CHANGE ORDER NO. 3
CITY OF BRYAN CEMETERY EXPANSION PROJECT
CITY JOB NO. 572-D5-1303

April 5, 2016

We are submitting Change Order No.3 to your contract for City Job No. 572-D5-1303. This change order provides for the following additions and deductions. All work to be performed in compliance with contract specifications.

CEMETERY EXPANSION PROJECT
KURTEN APRON REVISION

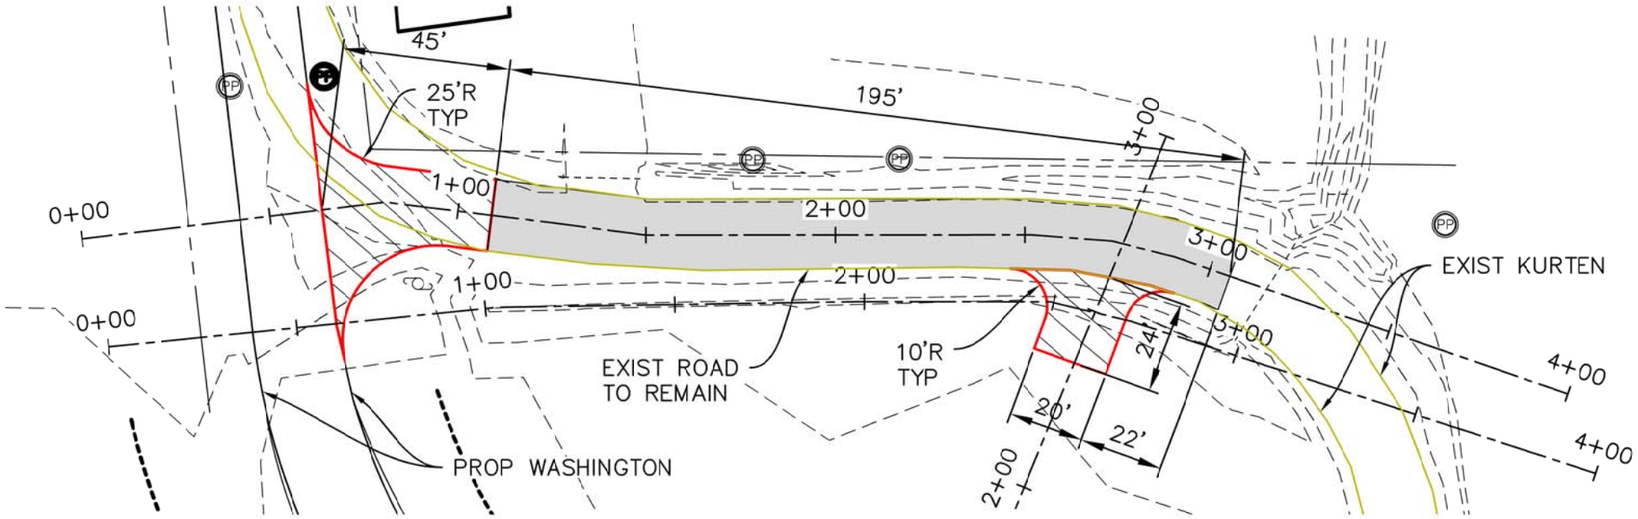
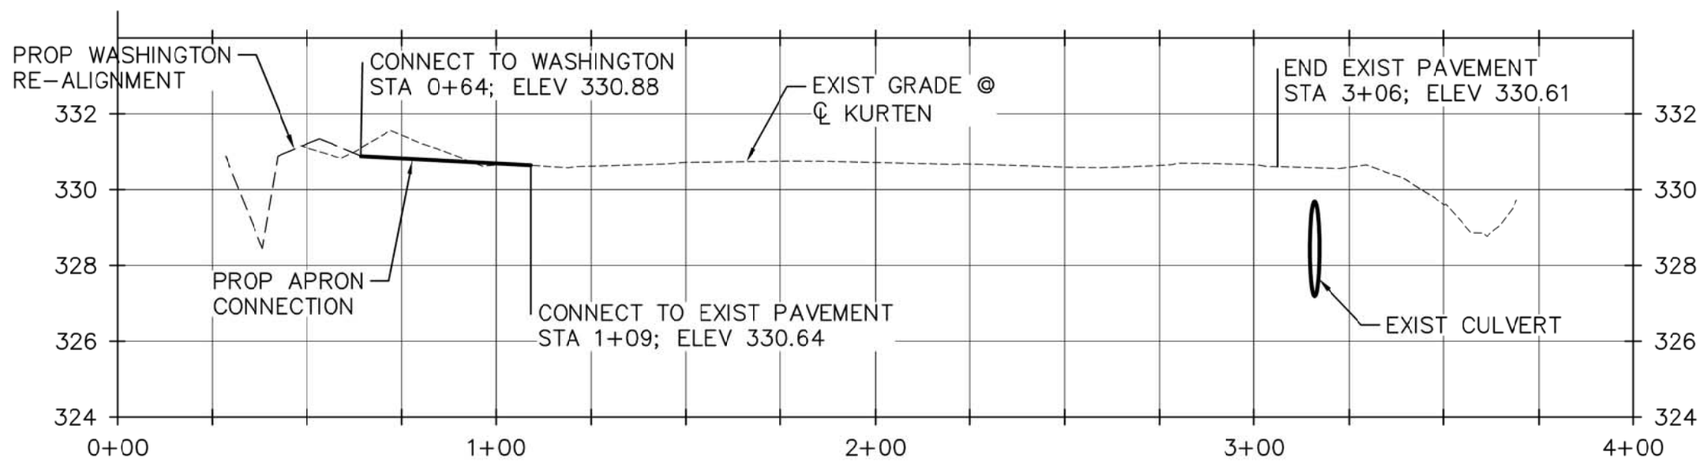
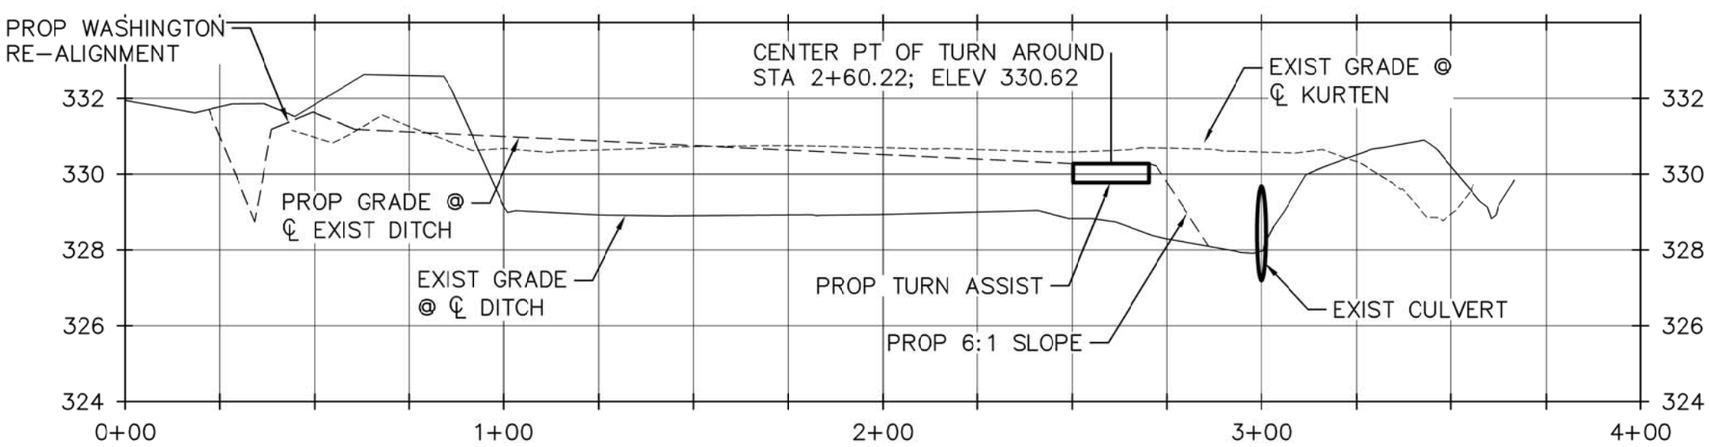
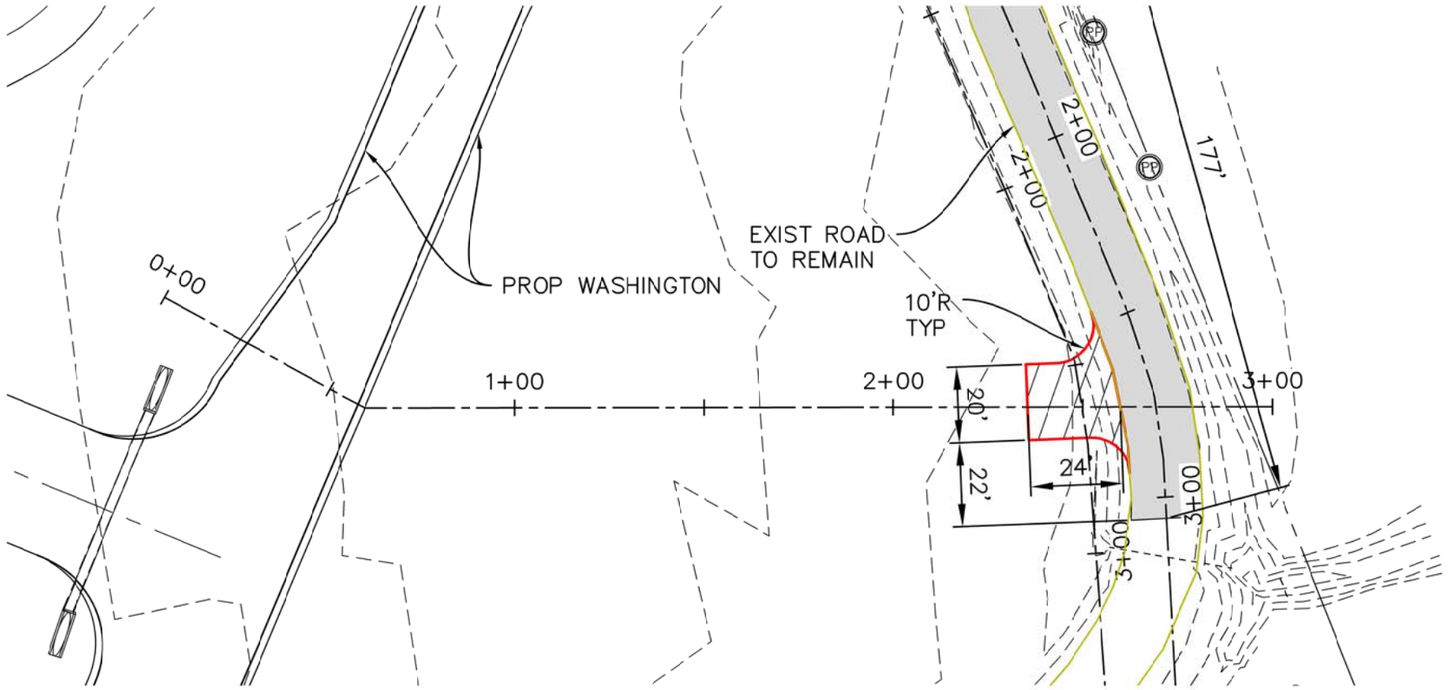
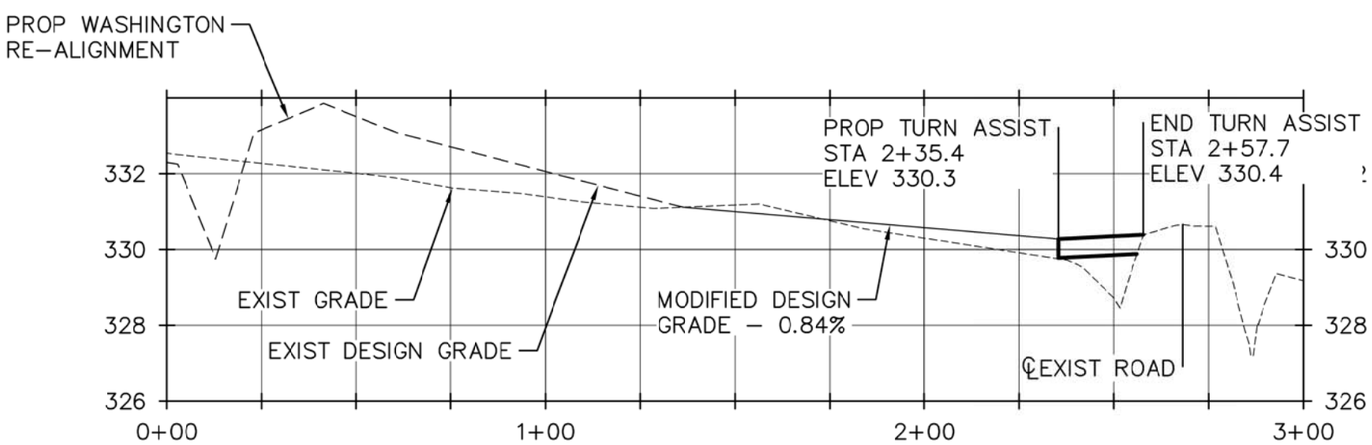
A. **Add: 12"-3% cement stabilization, 8" flexible base for Washington Road in accordance with recommendations from Geotechnical Investigation. Connection apron from Kurten to the new Washington Realignment and turn assist at end of road for future development of area NE of Kurten Road. New items for drainage re-design required due to conflict with water line discovered during construction.**
